DUNLOE PARK SAND QUARRY PROJECT Truck Movement Modification (MP 06_0030 MOD 2)

Environmental Assessment Report

Figure 2: Sensitive receivers and noise monitoring locations

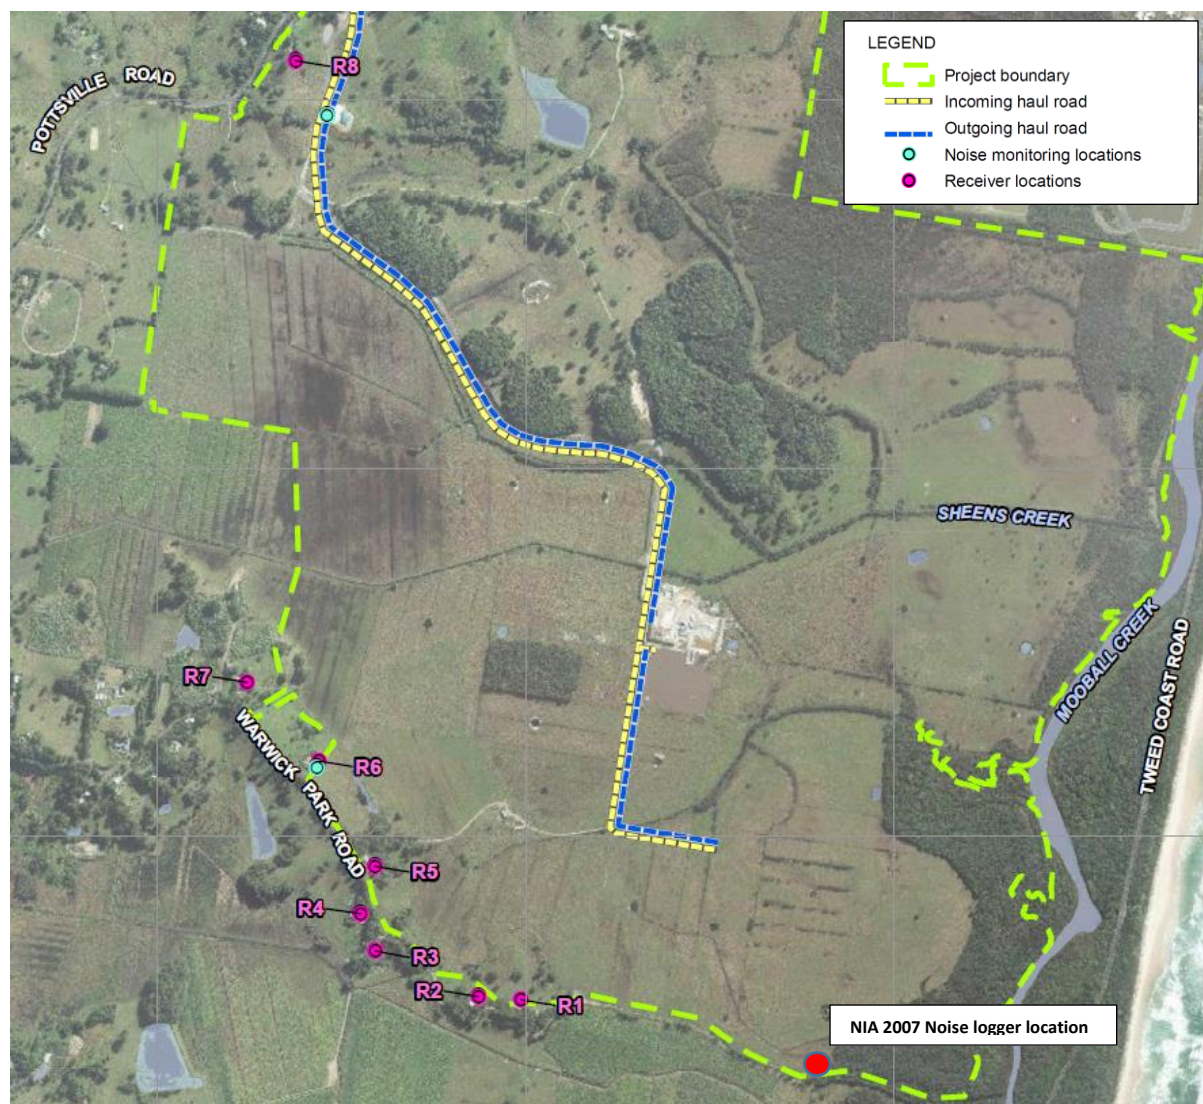
The NIA assessed the potential operational noise impacts of the modification against the currently approved noise criterion for the existing site operations of 48 $L_{Aeq(15min)}$ dB(A). The NIA identified the closest sensitive receivers as residences R1 to R8. Receivers 1 to 7 are located to the south-west of the Project boundary and are predominantly affected by operational noise from quarrying operations. Receiver 8 is located on the north-west boundary of the site and is predominantly affected by noise from the quarry access road (see **Figure 2**).

However, the 2007 NIA monitored background noise at just one location at the southern site boundary, which is isolated from any of the identified sensitive receivers and is close to Tweed Coast Road and breaking waves of the nearby beach (see **Figure 2**). This approach led to a relatively high background noise level of 43 dB(A). The Department now questions the relevance of the logger's location so distant from sensitive receivers and where the background noise level is elevated by ocean noise and road

The Department therefore considers that this modification application warrants reviewing the single noise criterion imposed under the original approval.

The NIA provided results of recent background noise monitoring at locations considered representative of sensitive receivers. For Receivers 1 to 7, the measured background level was 36 dB(A). Therefore, in accordance with the *Noise Policy for Industry 2017*, the project noise trigger level (PNTL), which is background + 5 dB(A), is 41 dB(A) ($L_{Aeq, 15min}$) for these receivers.

The NIA predicts that Receivers 1 to 5 would experience noise levels at or below the PNTL, and therefore, the Department considers it appropriate that the PNTL is adopted as the noise criterion for these receivers. Receivers 6 and 7 are predicted to experience noise levels of up to 42 dB(A), which is 1 dB(A) above the PNTL. The Department recognises that this 1 dB(A) difference would be inaudible to the human ear but, nevertheless, a noise limit of 42 dB(A) is recommended for these receivers.

The measured background noise level for Receiver 8 was 44 dB(A), which results in a PNTL of 49 dB(A). The NIA predicts that noise levels at this receiver would not exceed 46 dB(A). On this basis, the Department considers that the existing noise criterion of 48 dB(A) should remain for this receiver.

Figure 3: Sensitive receivers north of Dunloe

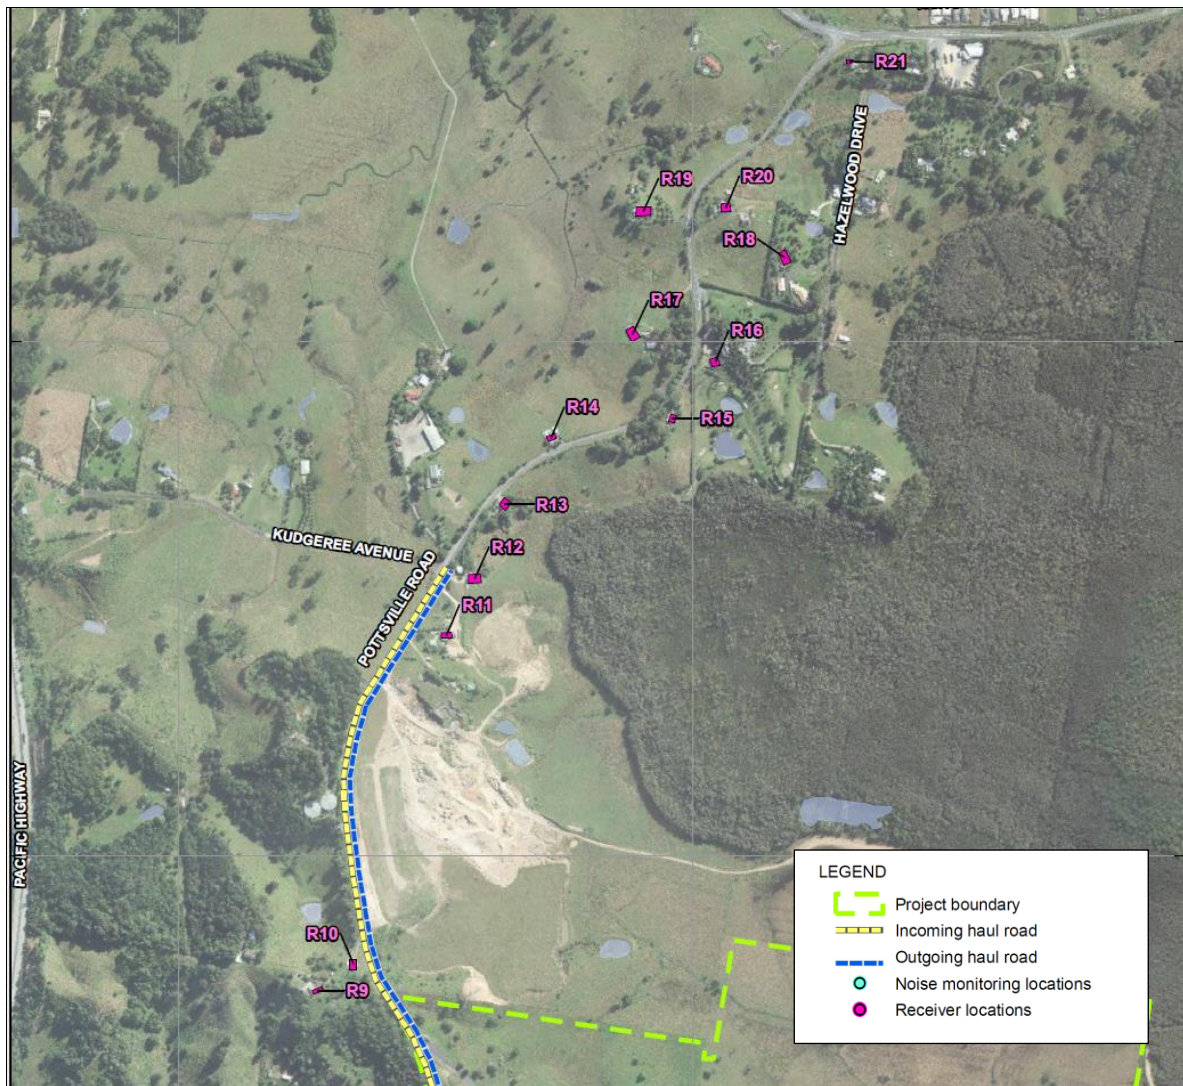
The NIA identified sensitive receivers along Pottsville Road as R9 to R21 (see **Figure 3**). The NIA indicated that predicted noise levels do not exceed the criterion for sub-arterial road noise (see **Table 3**). The highest expected noise level was predicted at R10 (57 dB(A)). This section of Pottsville Road has a steady incline from the intersection with the access road. Typically, a laden truck would be required to engage a lower gear to maintain higher engine speed to negotiate this incline. This scenario would account for the higher road noise predicted at R10.

One public submission was received stating that any increase in truck movements would be unreasonable due to the associated impacts on nearby residences. The Department acknowledges this concern. However, the RNP sets a road noise criterion of 60 dB(A) for traffic movements along Pottsville Road and the modification application does not seek to exceed this standard.

The Department has recommended that Holcim prepare and implement a contemporary Traffic Management Plan that details all management measures that Holcim would implement to reduce road noise emissions. The Department is satisfied that the road noise impacts from Dunloe's operations can be appropriately managed under modified conditions of approval.

Figure 4: Proposed vegetation removal in Pottsville Road reserve

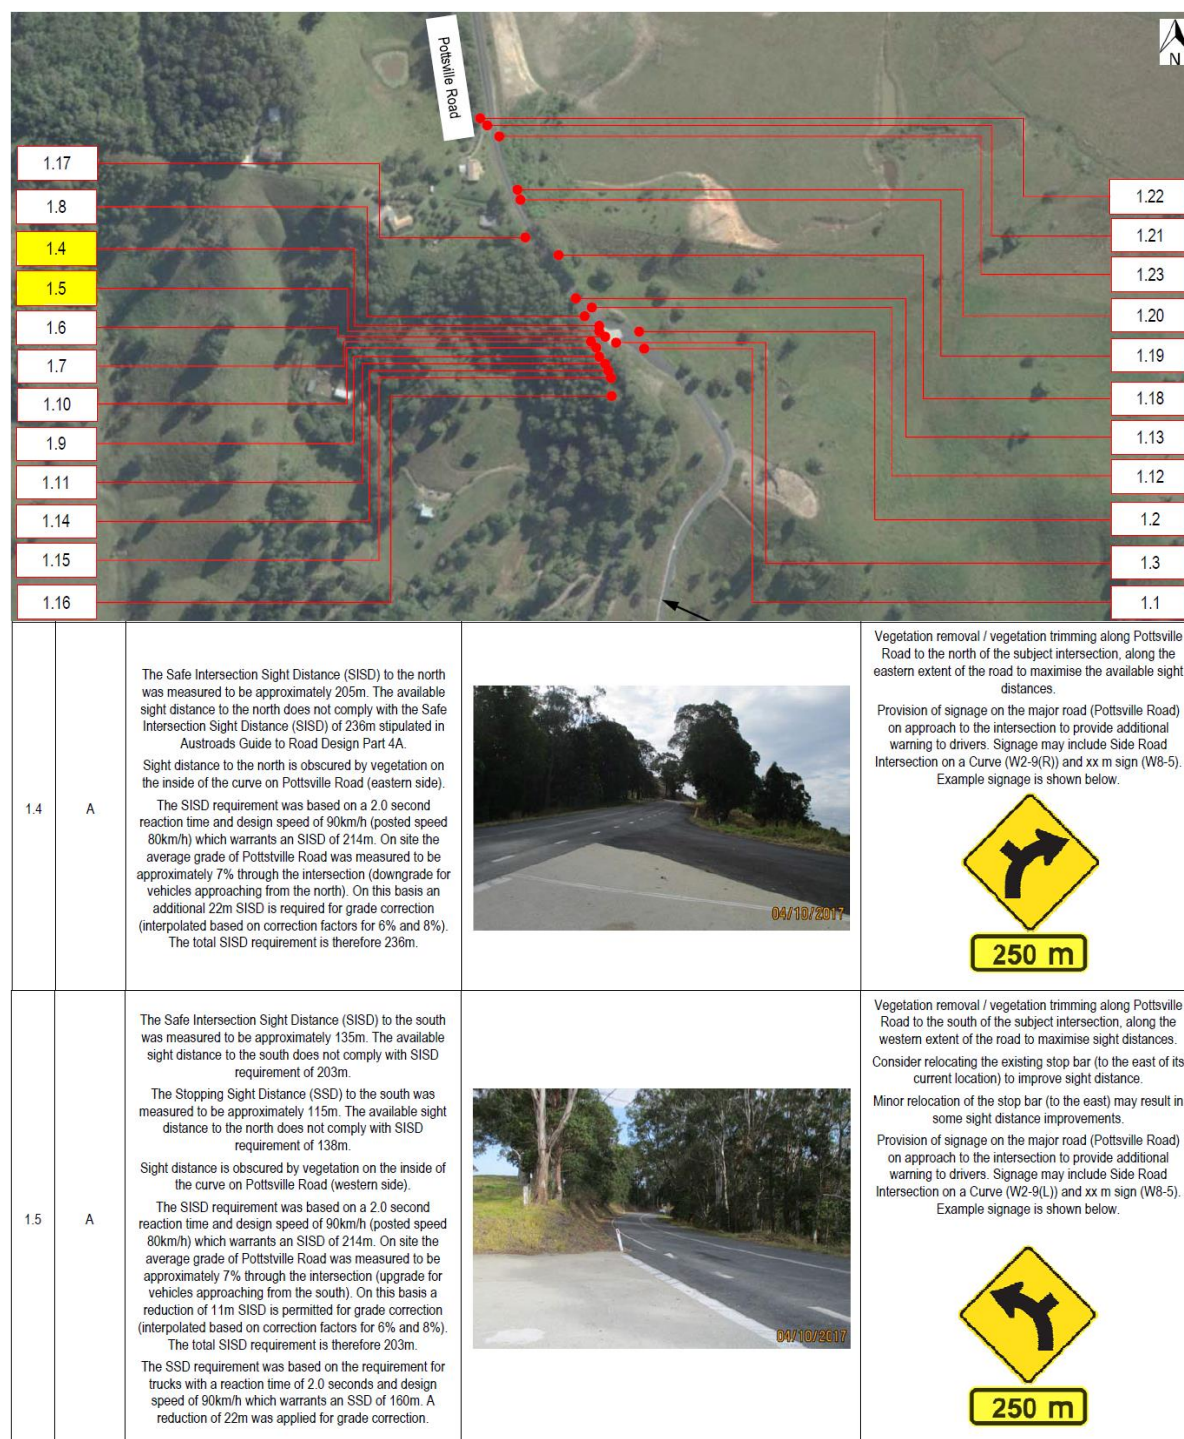
As discussed above, the RTS included an RSA in response to concerns about traffic safety, particularly sightline distances for vehicles entering Pottsville Road from the quarry access road. The RSA provided two recommendations (numbered 1.4 and 1.5) to improve sightlines by clearing vegetation within the Pottsville Road reserve (see **Figure 4**).

Council was strongly opposed to any vegetation clearance along the road reserve as the area is mapped as Koala habitat. Council also requested that Holcim undertake further environmental assessment of the potential impact on Koalas, particularly regarding road strike mortality and inconsistencies with its *Tweed Coast Comprehensive Koala Plan of Management 2015* (KPOM).

In response to Council's concerns about vegetation clearance, Holcim investigated alternative options to address sight distance limitations. These options were presented in an additional report which identified that no vegetation clearance in the Pottsville Road reserve would be required, subject to the implementation of other measures. Council agreed that these other measures (Option 1 Clear Zone provisions) would be sufficient and recommended a condition for their implementation prior to the commencement of any additional trucking from the site.

In response to Council's concerns about road strike, the Department sought advice from OEH regarding potential impacts to Koalas. OEH did not raise concerns about Koala mortality, as Dunloe's daytime-only operations pose a low possibility of road strike against animals which generally only move nocturnally. OEH recommended conditions requiring a monitoring program for Koala strike as well as adaptive management options. The Department has recommended a condition to this effect.
